STAFF REPORT

AGENDA ITEM: Metro Transit Park and Ride facility for the property on the south

side of Hudson Blvd, west of Manning Avenue

Engineering Plan Review

I-94 AND MANNING AVENUE PARK AND RIDE STATION
11530 HUDSON BOULEVARD NORTH
GRADING, DRAINAGE & EROSION CONTROL PLAN

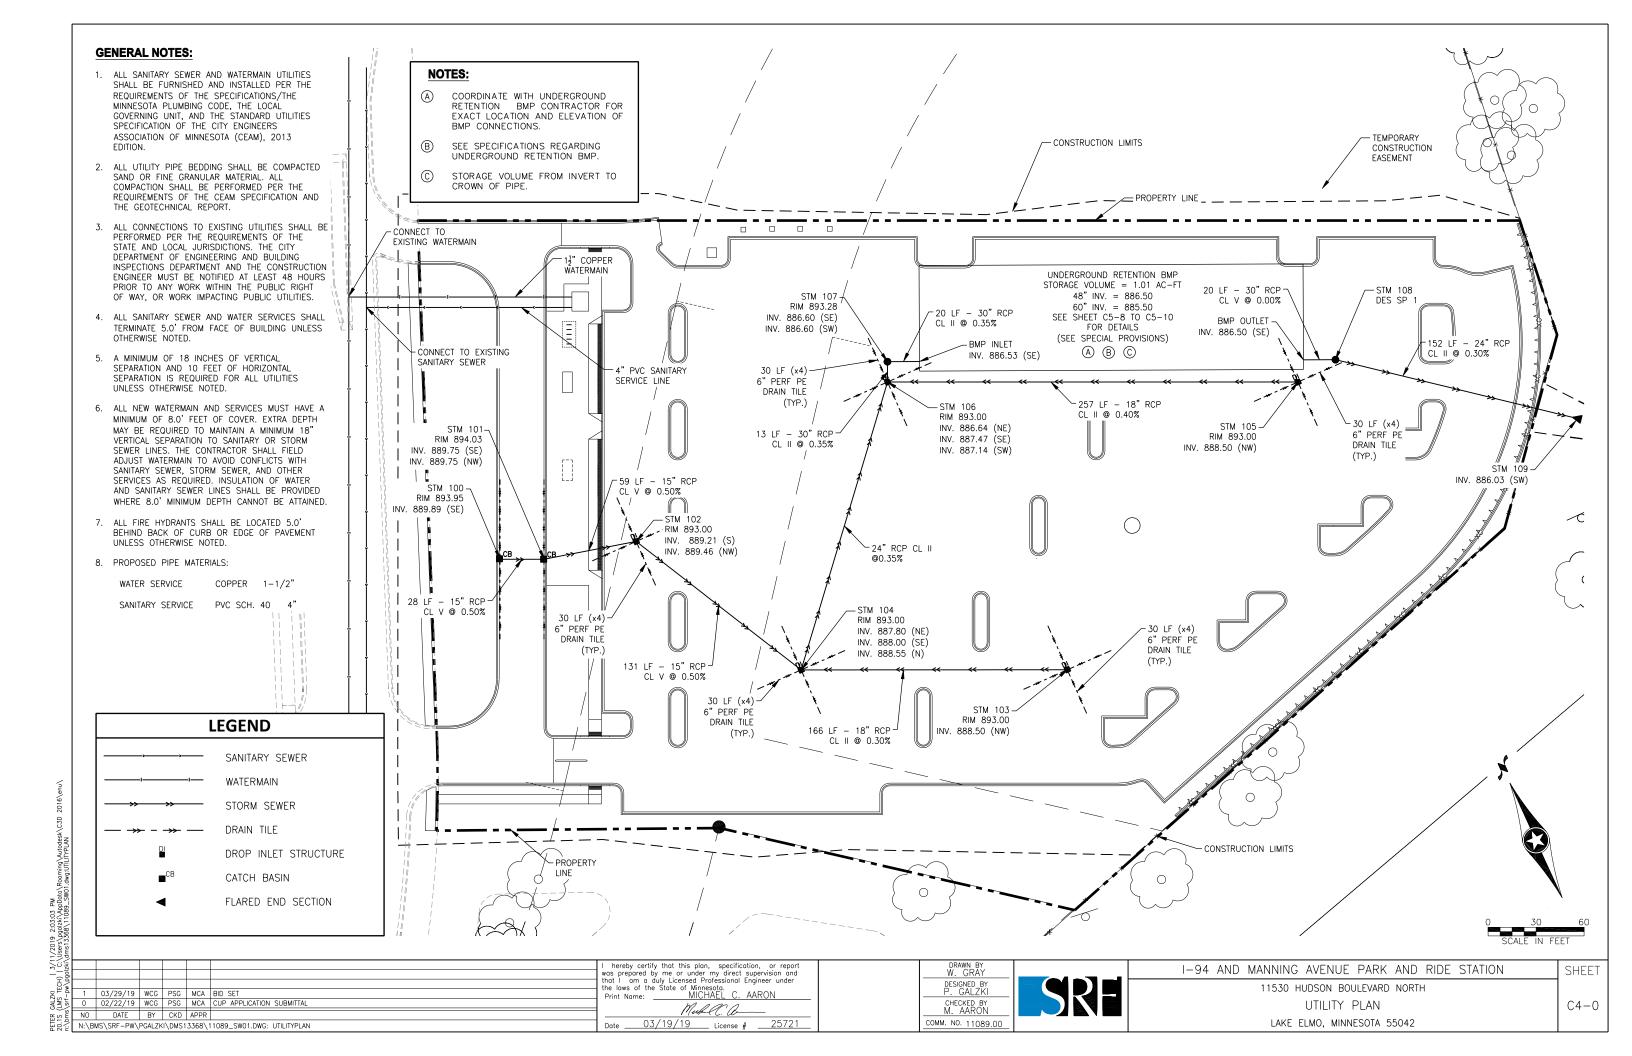
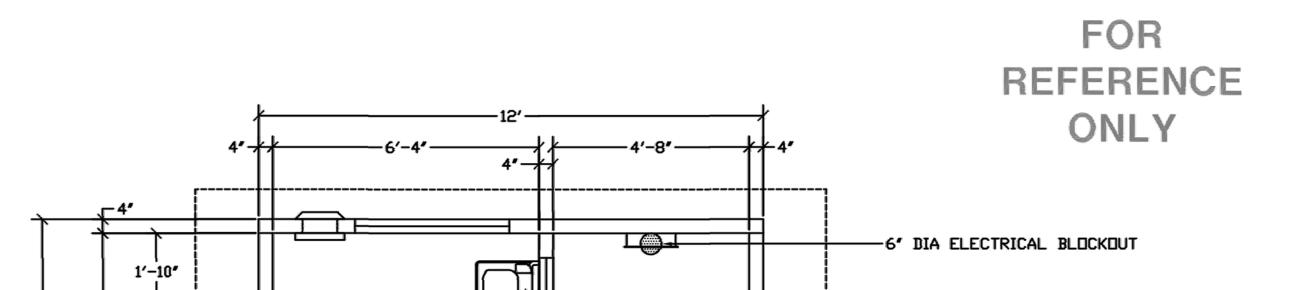
- C3.0. Grading, Drainage and Erosion Control. Revise the erosion control plans to include the City of Lake Elmo standard plan notes for erosion control and City standard details for erosion control. The specifications must be updated to include the City of Lake Elmo standard specifications for erosion control. The City specifications, details and plan notes must be identified to supersede all other plans and specifications in case of conflict.

- C3.0. Grading, Drainage and Erosion Control. Revise plans to identify Hudson Boulevard as "proposed" and to be constructed "by others". Add plan note that grading revisions may be required to match into the final constructed grades for Hudson Boulevard.

- C3.0. Grading, Drainage and Erosion Control. Add erosion control and restoration measures at the storm sewer outfall pipe off-site.
- C4.0. Utility Plan. Revise the utility plans to show the sewer and water service connections to be located at the right-of-way of Hudson Boulevard. The public improvement project must be updated to provide sewer and water service stubs from the mains to the right-of-way consistent with City of Lake Elmo standard service details.

C5-27

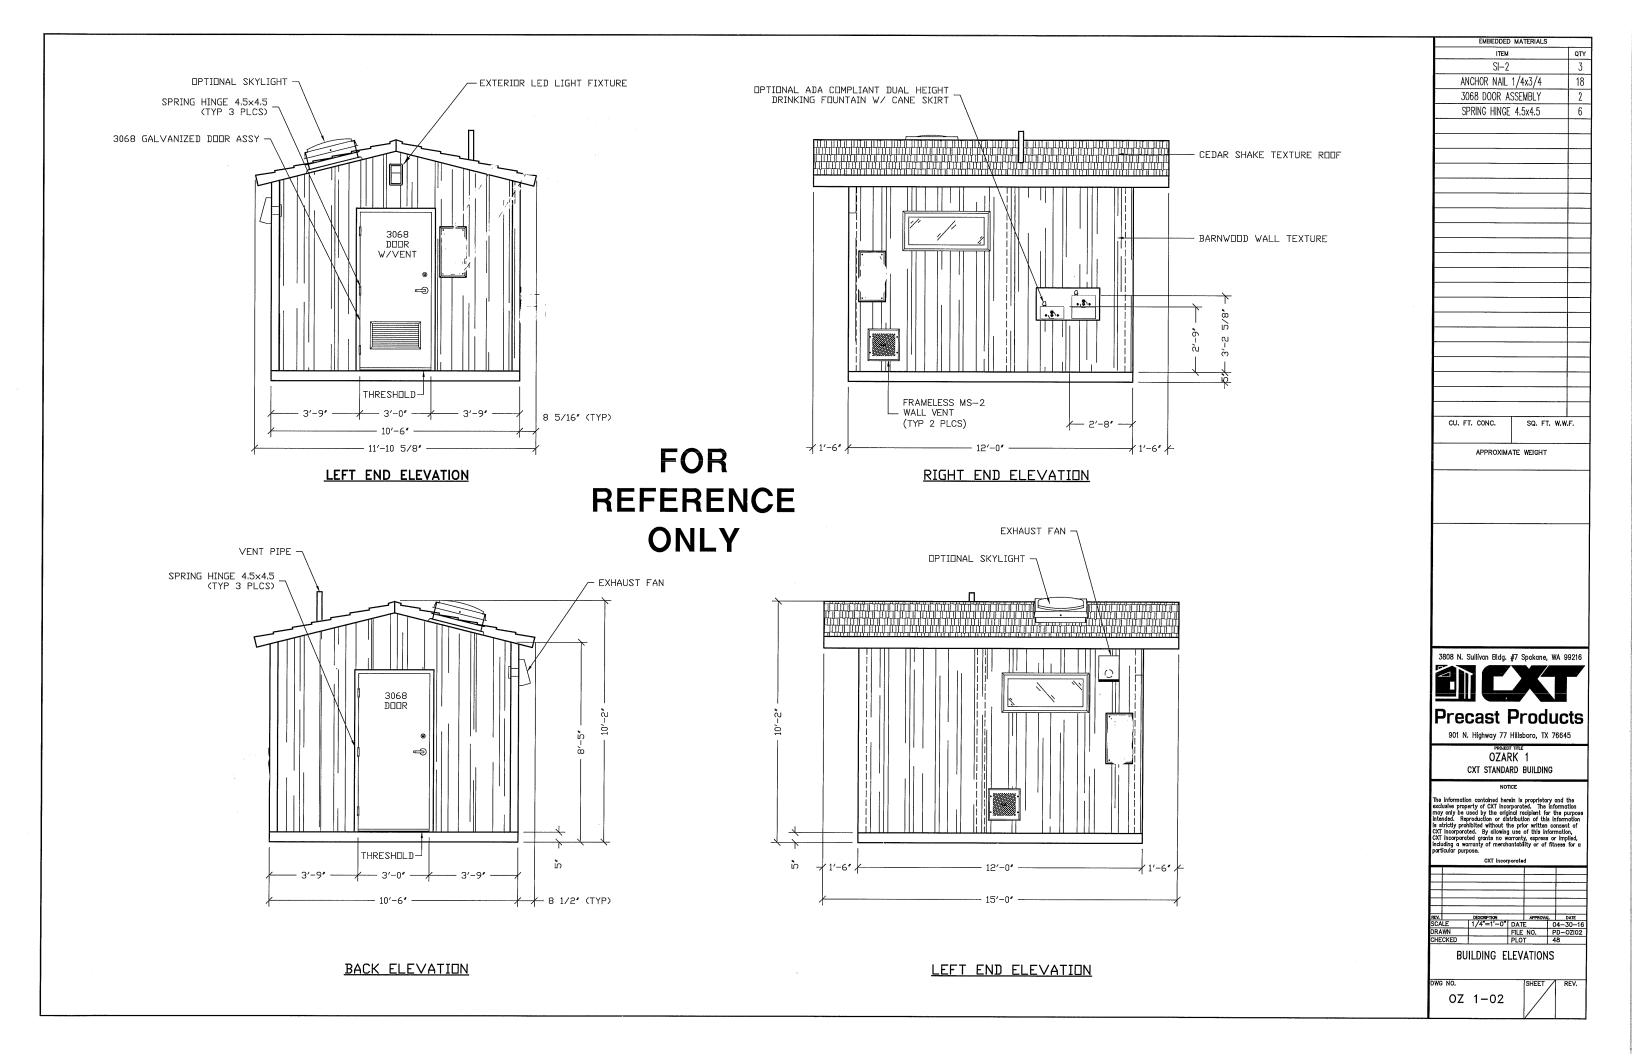
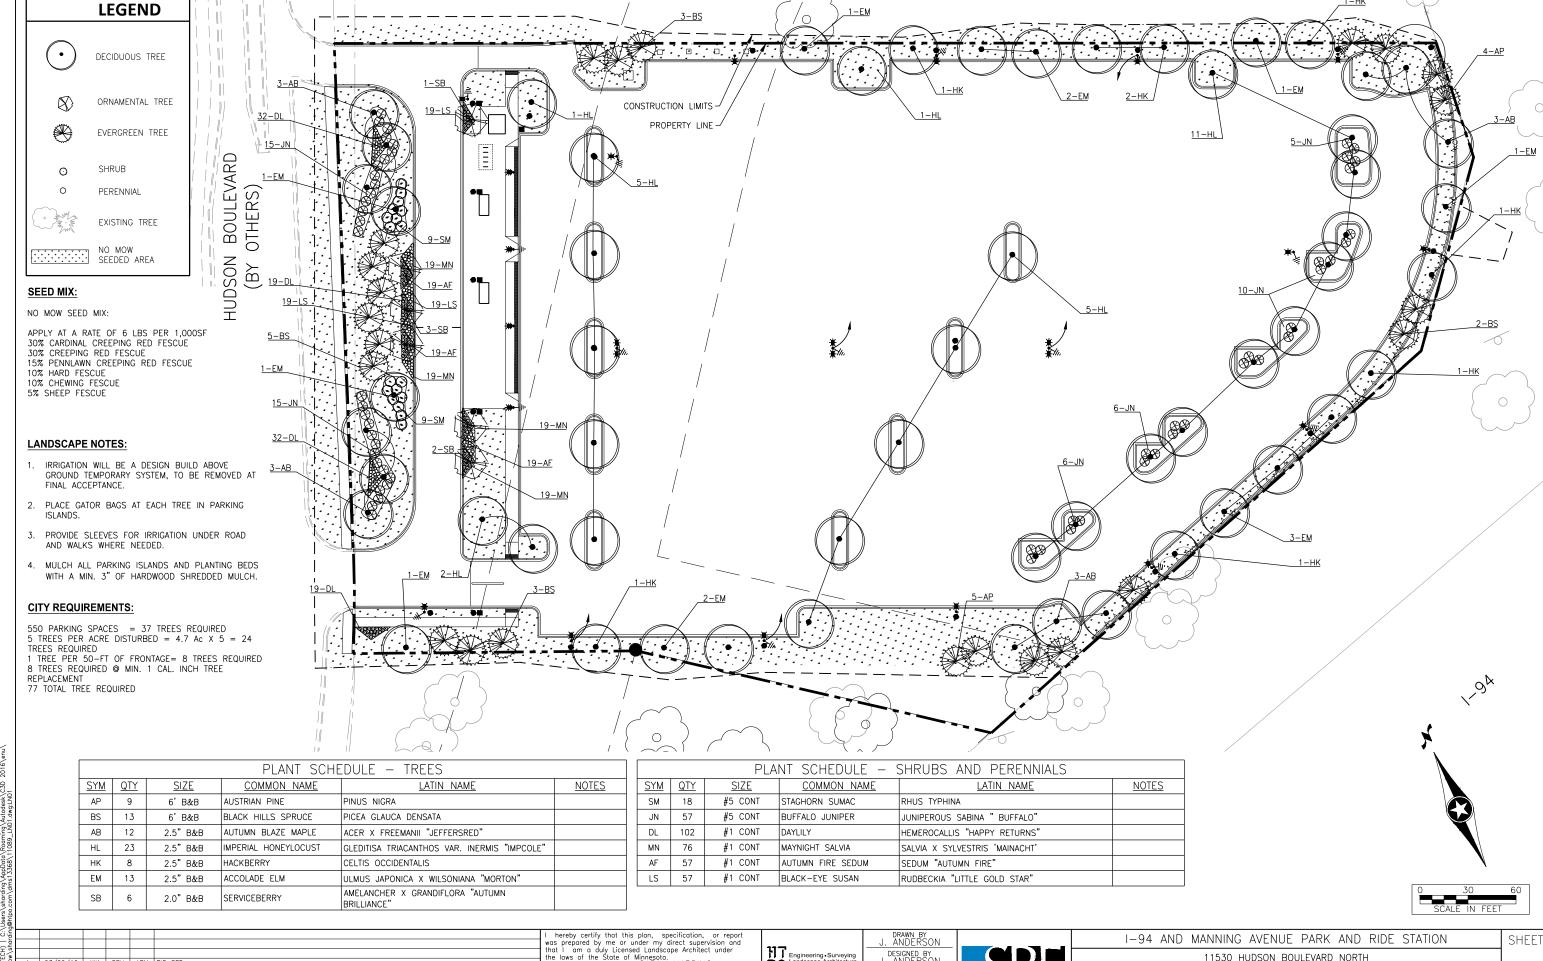
- C5-X. Civil Details. The plans must be revised to replace all civil details, plan notes and specification for erosion and sediment control to meet the standards of the City of Lake Elmo.

LANDSCAPE PLAN LAKE ELMO, MINNESOTA 55042

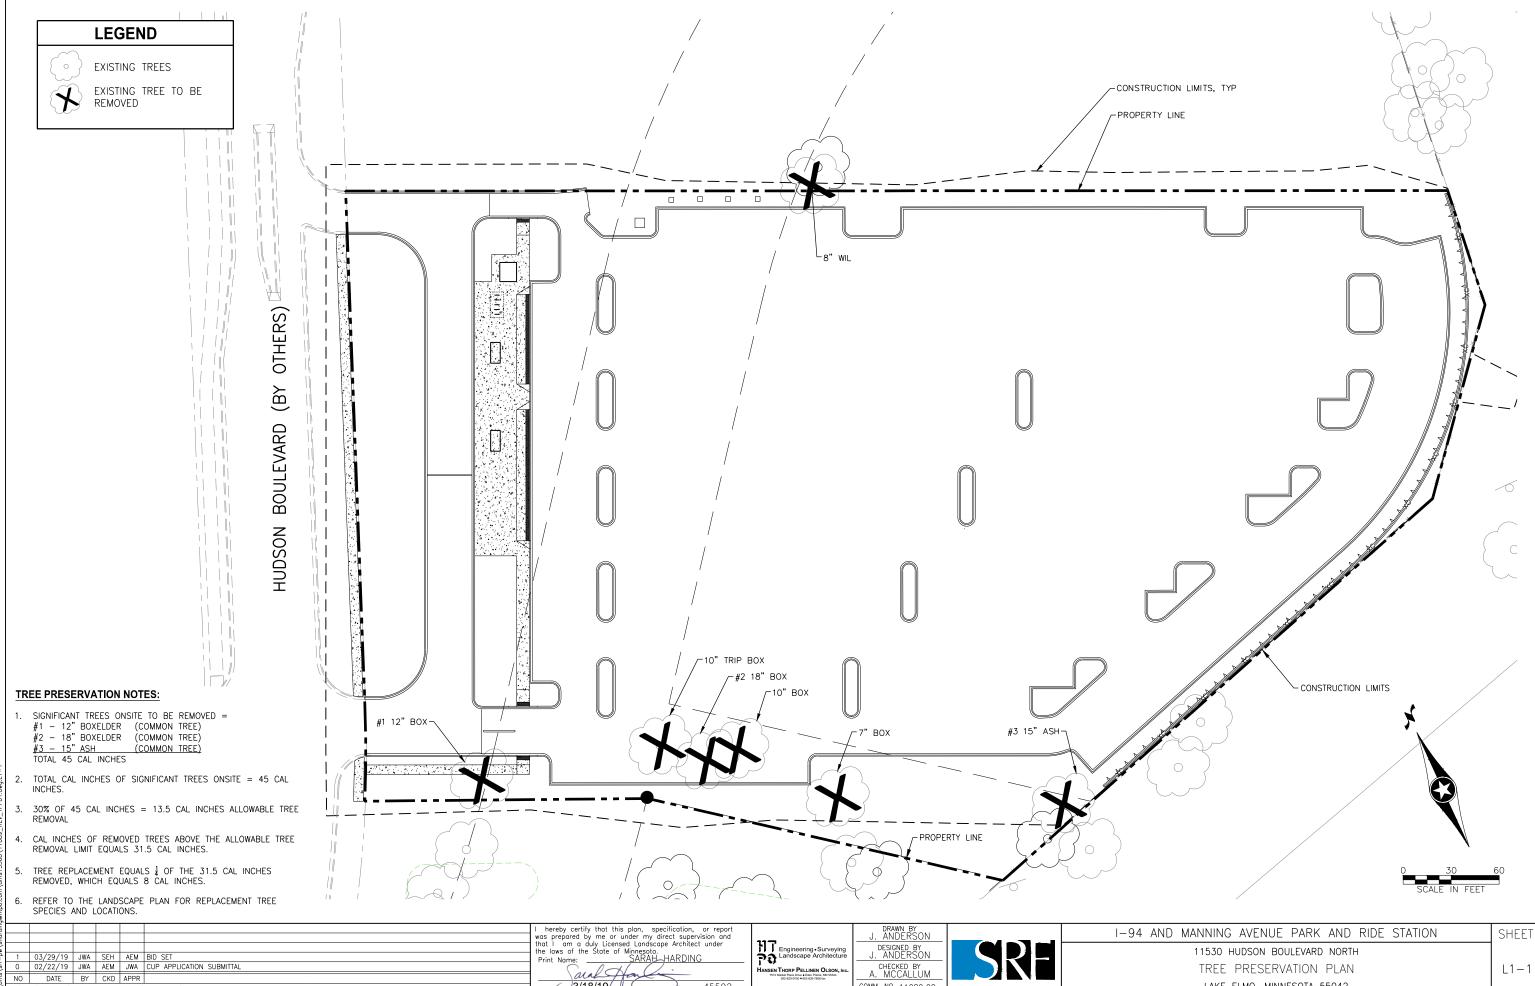
- L1.0. Landscape Plans. All proposed utilities must be shown on the landscape plans and all trees relocated to maintain 10 feet of separation from all public utilities.

- A. A landscape plan has been submitted that does not include all requirements.
 - 1. Utilities are not shown on the landscape plan to review for tree placement conflicts.

1. Submit a revised landscape plan showing locations of utilities to review that all trees are 10' minimum away from utility lines.
